ZONING CHANGE REVIEW SHEET

CASE: C14-2008-0234 ZFB, Ltd. Rezoning

ADDRESS: 9710 & 9718 Anderson Mill Road

Critical Environmental Feature Summary
ZFB Zoning application, Case No. C14-2008-0234
(aka Marquis Ranch Self Storage site plan SP-2008-0090D)
9718 Anderson Mill Road

Exhibit A
(1)

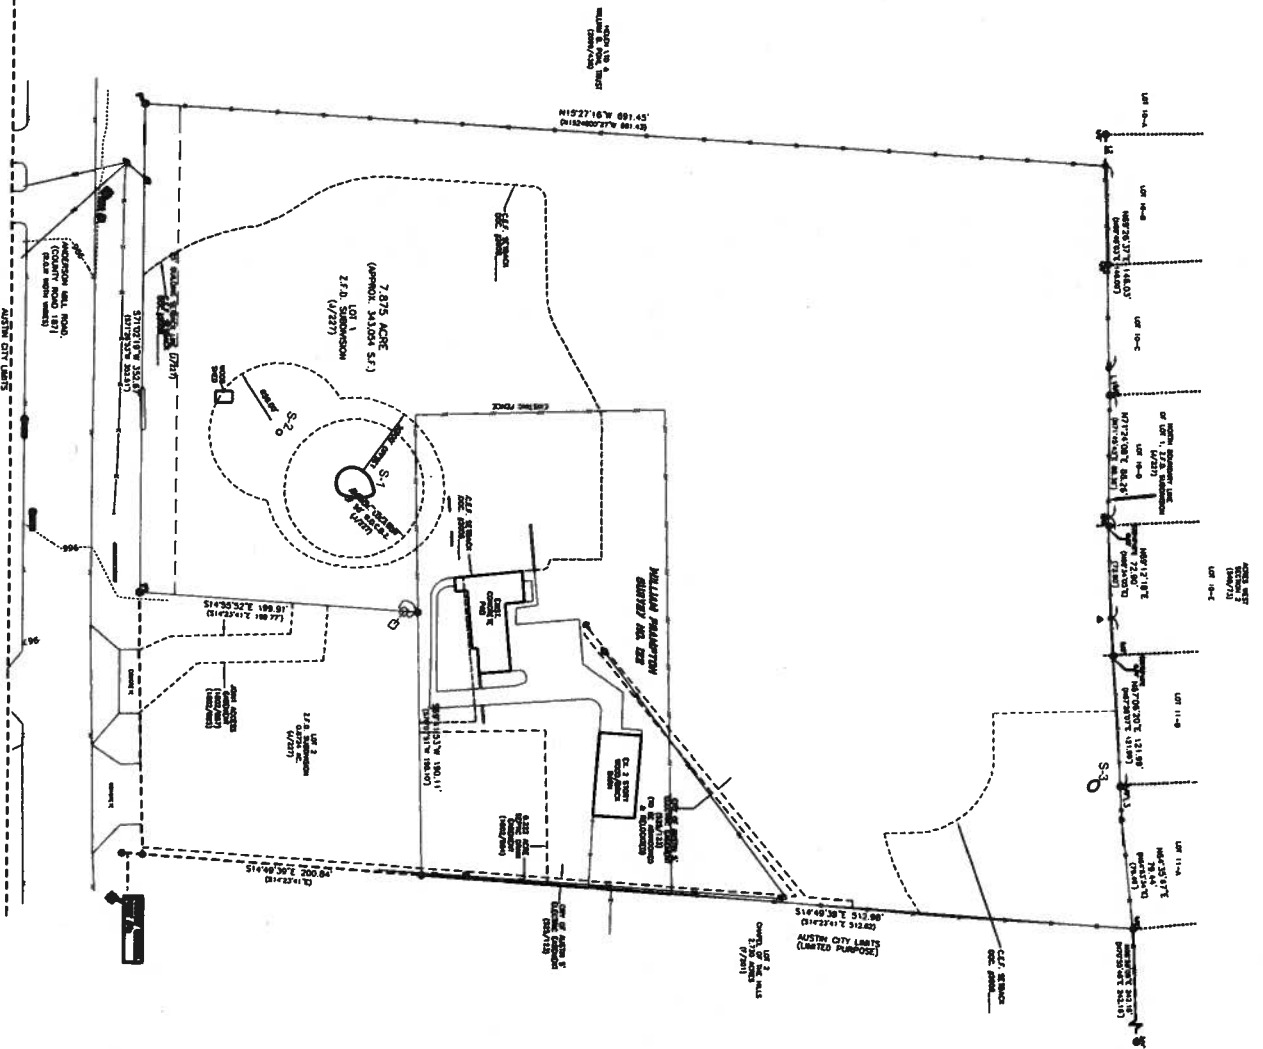
Identify the locations of sinkhole Critical Environmental Features S-1, S-2 and S-3 and their associated buffer areas. The locations of these features are shown in Exhibit A(1) and A(2). Metes and bounds descriptions for the 2.089 acre buffer for S-1 and S-2 are referenced as Exhibit "B" and metes and bounds descriptions for the 0.433 acre buffer of S-3 are referenced as Exhibit "C."

Exhibit "B"

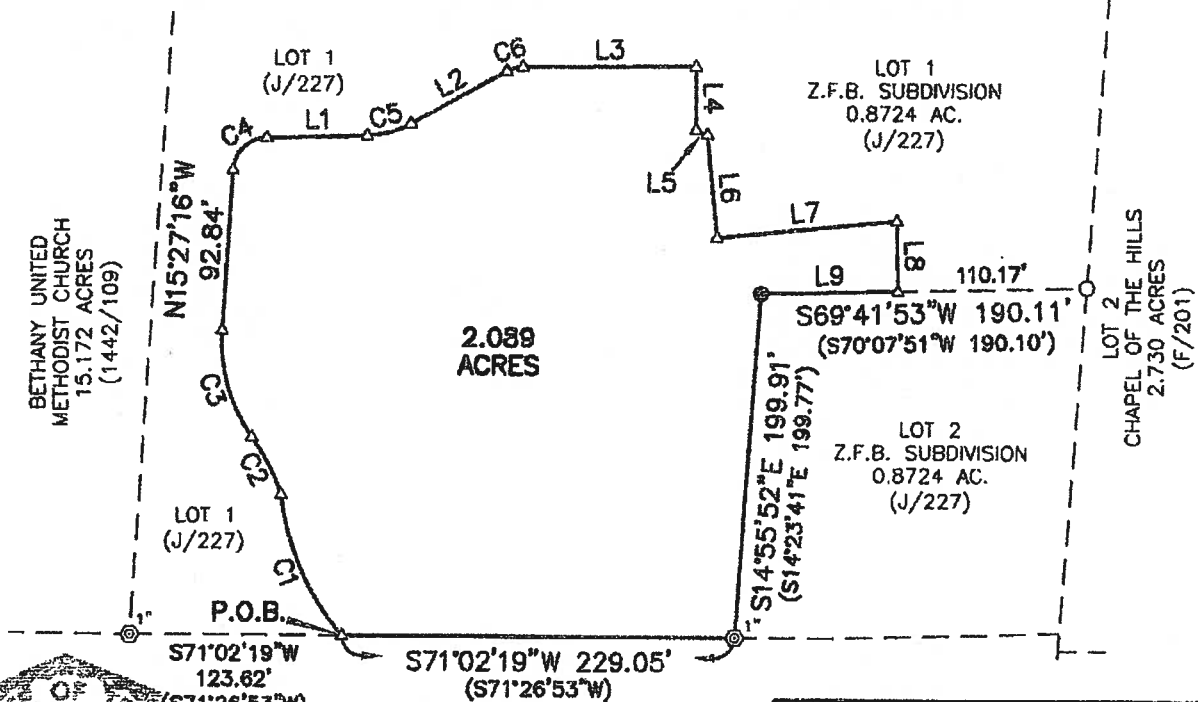
1. Identify the locations of sinkhole Critical Environmental Features S-1, S-2 and S-3 and their associated buffer areas. The locations of these features are shown in Exhibit "A." Metes and bounds descriptions for the 2.089 acre buffer for S-1 and S-2 are referenced as Exhibit "B" and metes and bounds descriptions for the 0.433 acre buffer of S-3 are referenced as Exhibit "C."
